Sandy Creek Energy Station
Coal Combustion Residual Waste
Management Facility
Registration Application
TCEQ Registration No. CCR107
McLennan County

Technical Notice-of-Deficiency
Response 2

Subject: Sandy Creek Energy Associates, LP – Riesel, McLennan County
CCR Registration No. CCR107
Response to Technical Notice-of-Deficiency 2
Tracking No. 27237612; CN604335455/RN105905657

Sandy Creek Services, LLC, Coal Combustion Residuals Registration No. CCR107
September 22, 2022 Notice-of-Deficiency Response Table

DRAWING TITLE	CROSS SECTION LAYOUT PLAN
PROJECT TITLE	SANDY CREEK ENERGY STATION CCR WASTE MANAGEMENT FACILITY TCEQ REGISTRATION APPLICATION

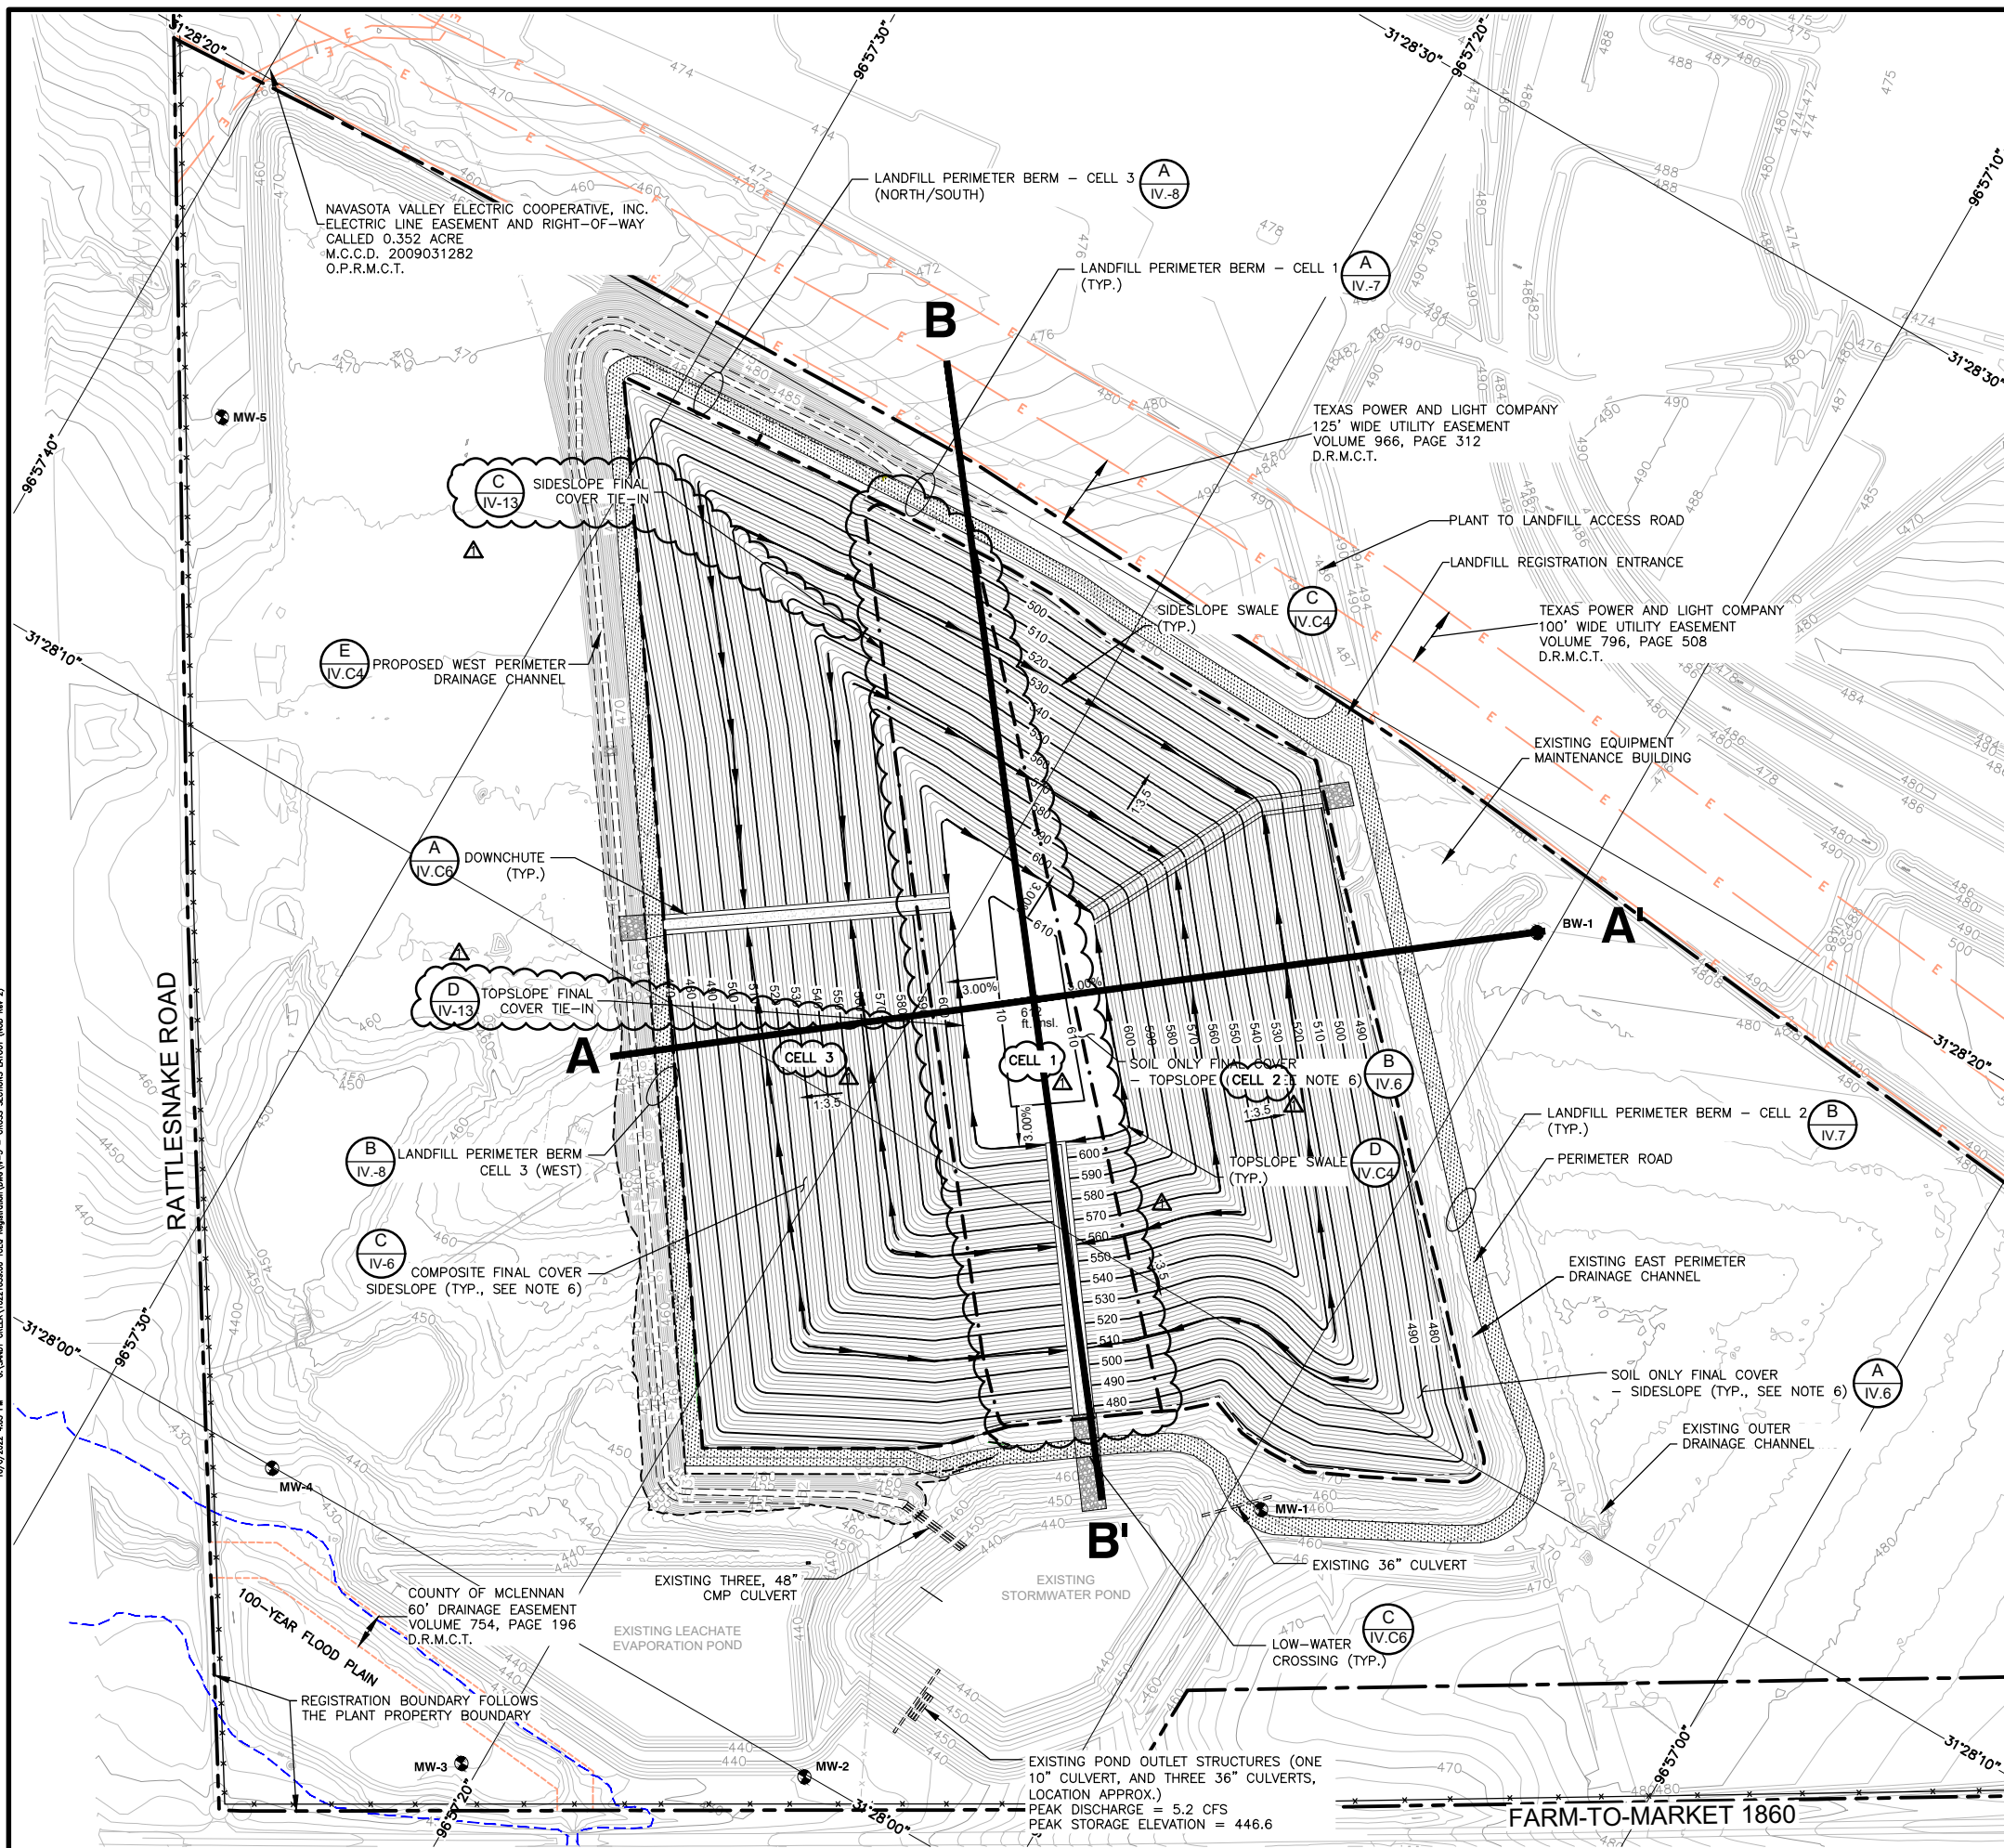
NOD ID	APP. Section	App. Sub Section	Location	Citation	NOD Description	Response
1	IV	IV.25.F	Table IV.D	Application Instructions 40 CFR 257.84(a)(i)	Revise table to indicate that weekly inspection items will be conducted at intervals not exceeding 7 days.	In accordance with 40 CFR 257.84(a)(i)), Table IV.D and Table 3.1 in Part V – Site Operating Plan have been revised to indicate that weekly inspection elements will be inspected at intervals not exceeding seven days.
2	IV	IV.25	[Drawing IV-3]	40 CFR 257.70(d)	Revise Drawing IV-3 to show a Leachate Collection Sump for Cell 2.	Although a callout to indicate the location of the leachate collection sump for Cell 2 was already depicted on Drawing IV-3, this drawing has been revised to further indicate the leachate collection sump location in Cell 2.
3	IV and VII	IV.25 and VII.31	[Drawing IV-10]	40 CFR 257.7	Remove “optional” for Top Slopes (design for Composite Final Cover) and indicate that composite final cover is required for Cell 3.	<p>In accordance with 40 CFR §257.102(d)(3)(I)(A), the permeability of the final cover system must be less than or equal to the permeability of any bottom liner system. Since Cell 3 is the only cell that has a composite liner system, a composite liner system (having permeability less than or equal to the bottom liner system) is only required over Cell 3, as indicated in Note 1 on Drawing IV-10. Since the topslope is not overlying Cell 3 (overlays portions of Cells 1 and 2), composite final cover on the topslope is not required. However, and in accordance with Note 3 on Drawing IV-10, composite final cover may be installed over Cells 1 and 2 (including on the topslope) at the discretion of the Landfill Owner/Operator. Therefore, composite final cover on the topslope is optional and “(Optional)” indicated on Detail D on Drawing IV-10 does not need to be removed.</p> <p>To clarify the locations of soil only and composite final covers, Drawings IV-4, IV-5, and IV-6 have been revised to include cell boundaries. Additionally, callouts and revisions to notes have been made on Drawings IV-4, IV-5, and IV-6 for clarity purposes.</p>
